2 - ADDENDUM #31
 3/2/2018
 1 - ADDENDUM #2
 2/22/2018

A NEW REMODEL PROJECT FOR:
SHERWOOD HIGH SCHOOL
 16956 SW MEINECKE ROAD
 SHERWOOD, OR

DRAWN BY: EVK
 CHECKED BY: SWM
 DATE: 1-30-18
 TITLE: PARTIAL HVAC FLOOR PLANS
 SCALE: 1/8" = 1'-0"

A NEW REMODEL PROJECT FOR:
SHERWOOD HIGH SCHOOL
SHERWOOD, OR
16956 SW MEINCKE ROAD

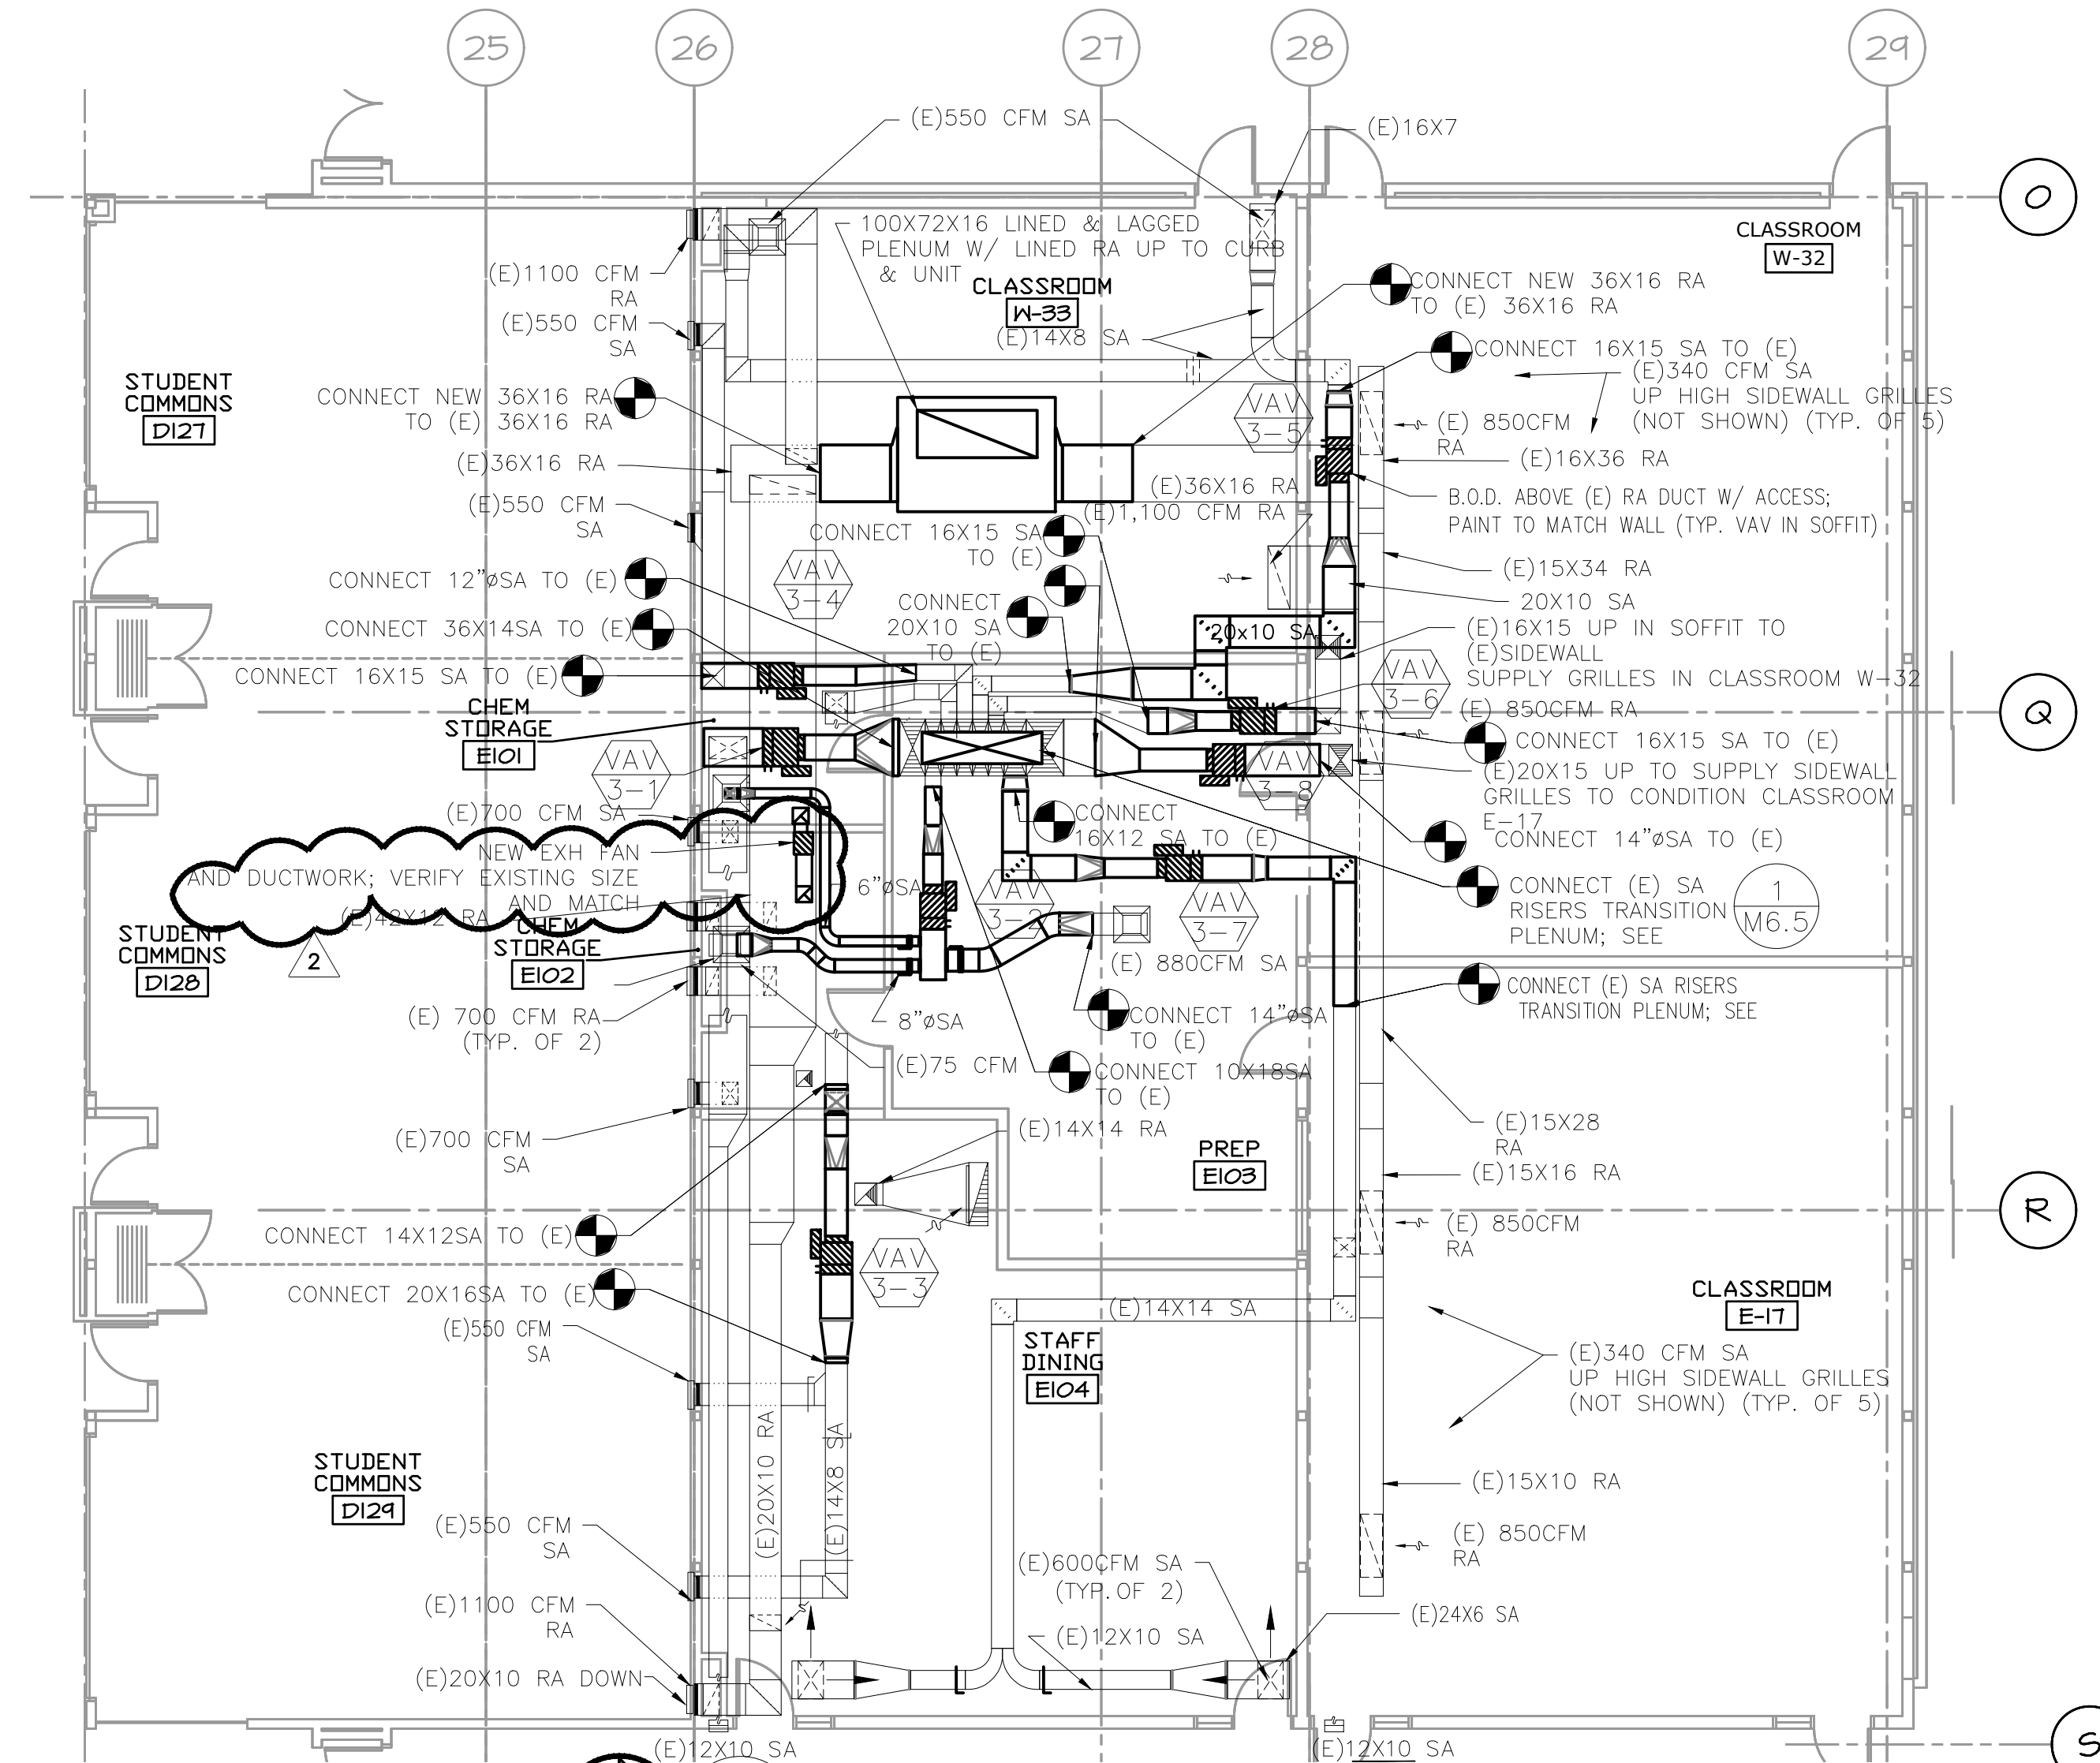
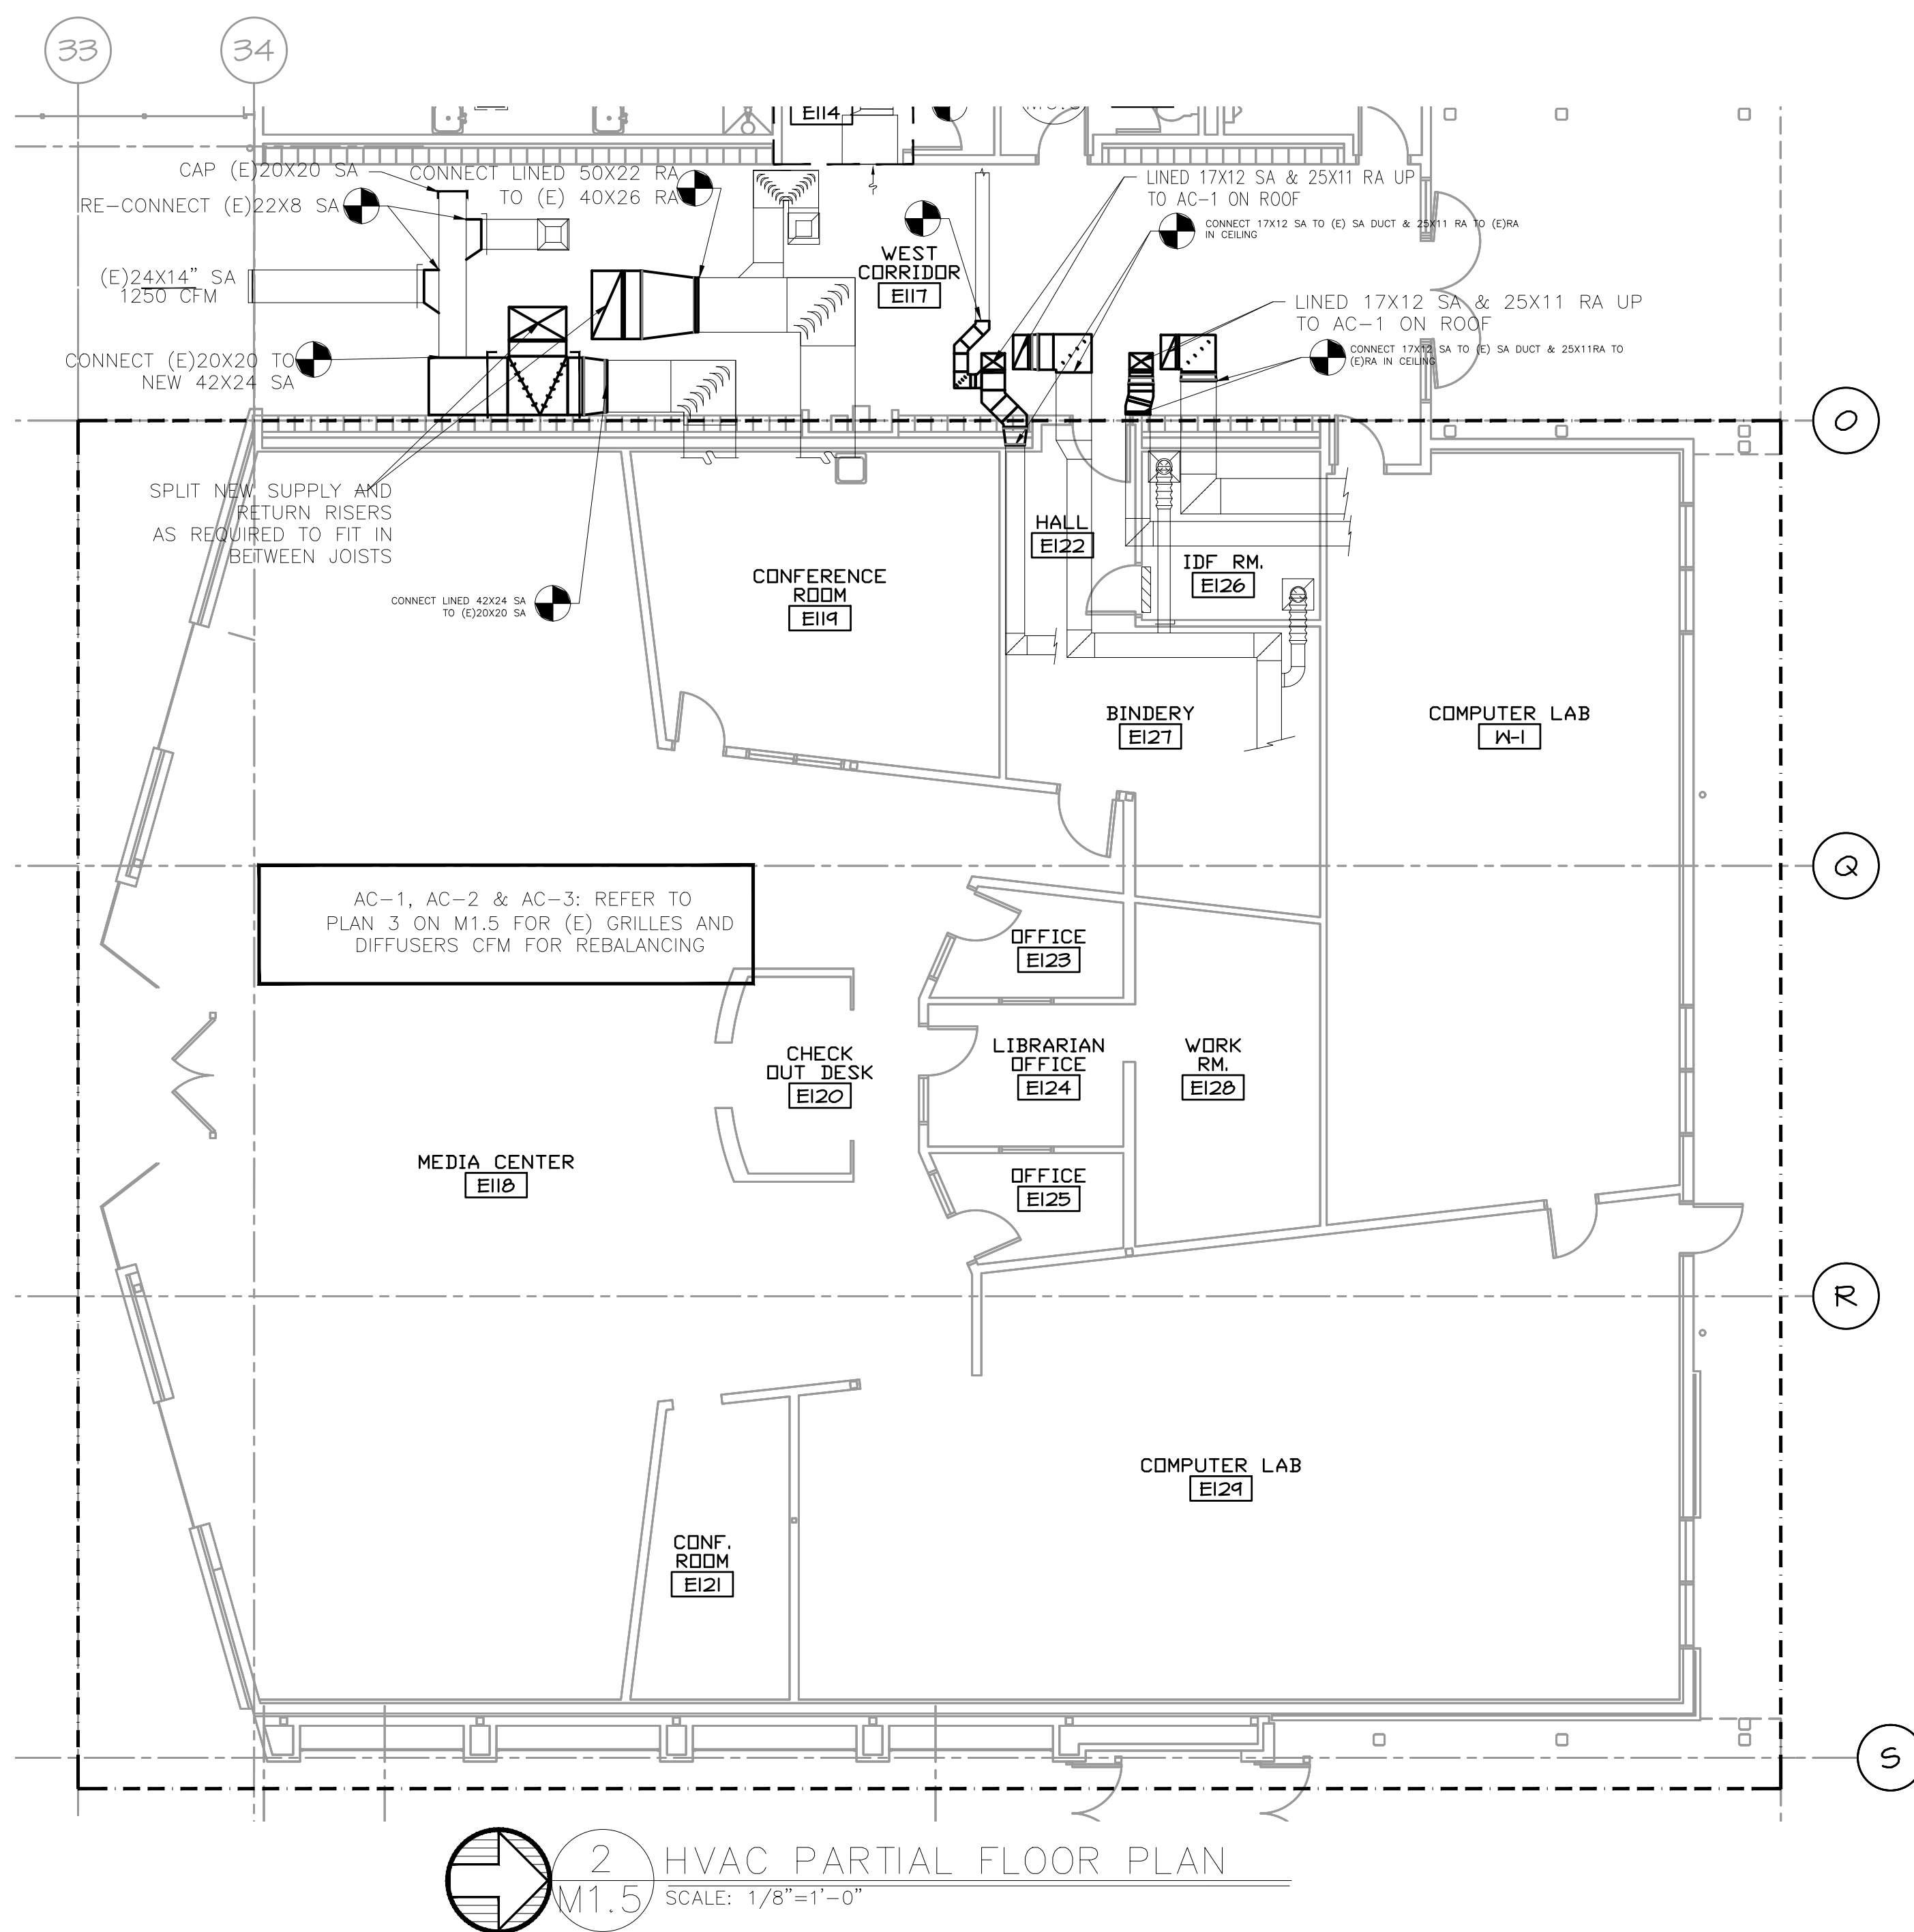
SHEET IS REVISED PER ADDENDUM #2.
